DEVELOPMENT REVIEW BOARD REPORT

Aire on McDowell
26-DR-2016

Request: Approval of the building elevations, perimeter theme wall design, and entry feature for a new residential subdivision, with 80 lots on an approximately 6.8-acre site.

McDOWELL ROAD WALL COMPOSITE

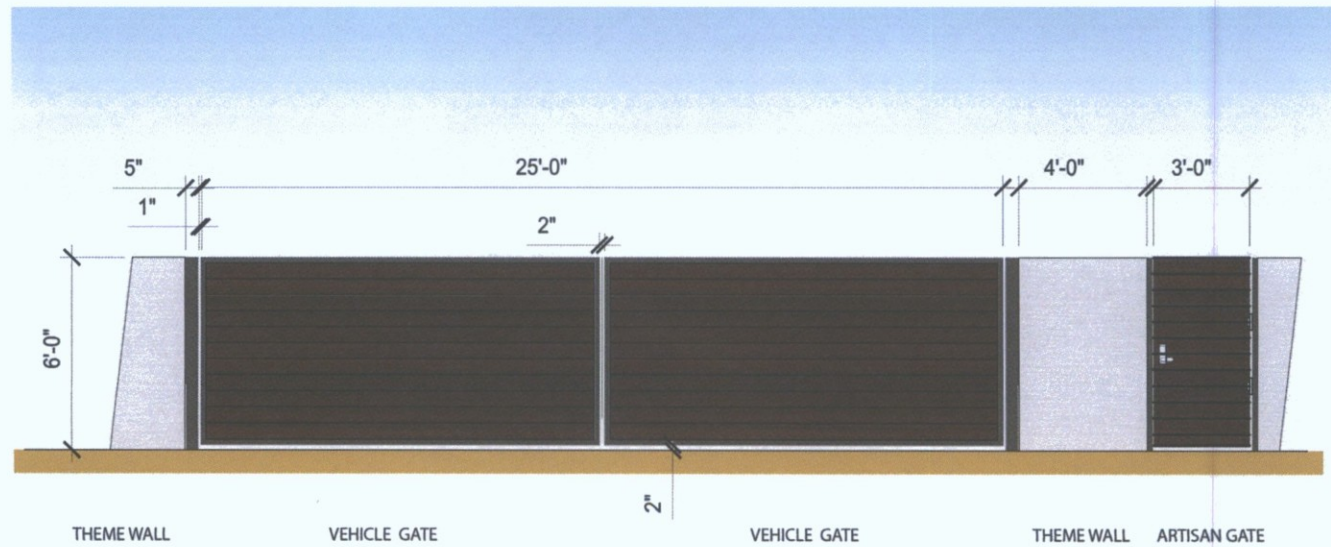
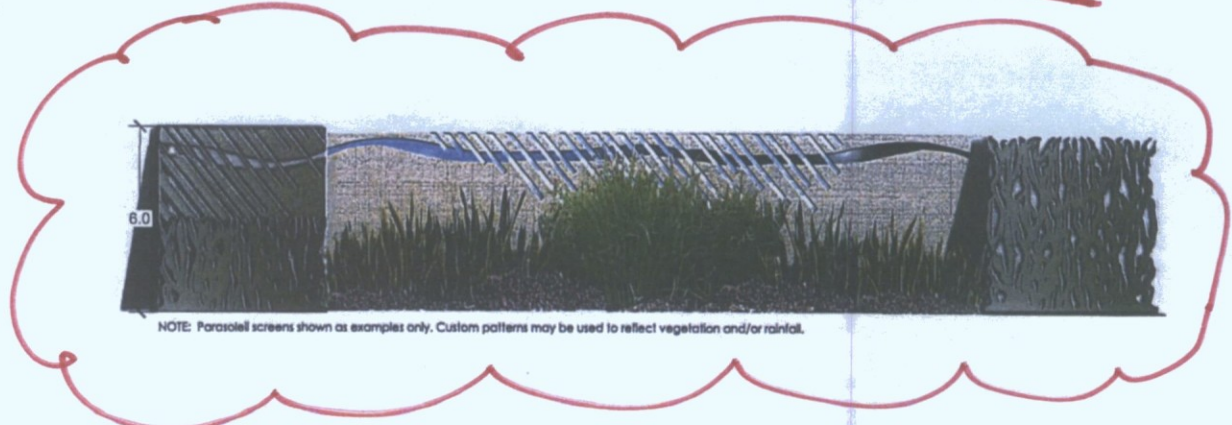
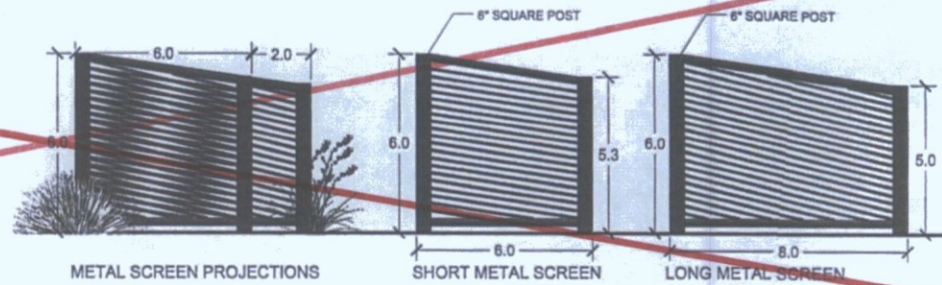
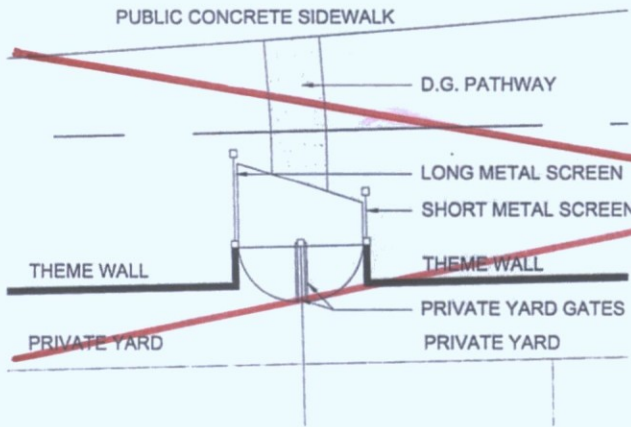
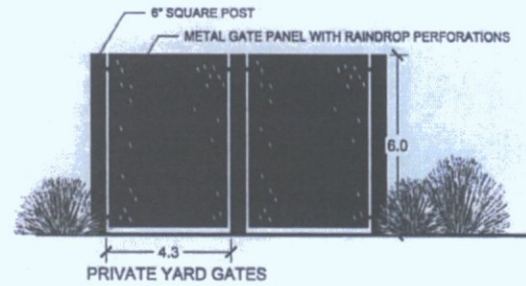
- ~~2. Art Theme Wall design shall be consistent with the design provided as part of the zoning case (15-ZN-2015) and included as Attachment #6 to this report, without the "wave" element.~~

5. *The proposed vertical slate elements on the thematic art wall shall either be recessed into the wall, or extend out from the surface of the wall to provide additional articulation and depth, to the satisfaction of Current Planning staff.*
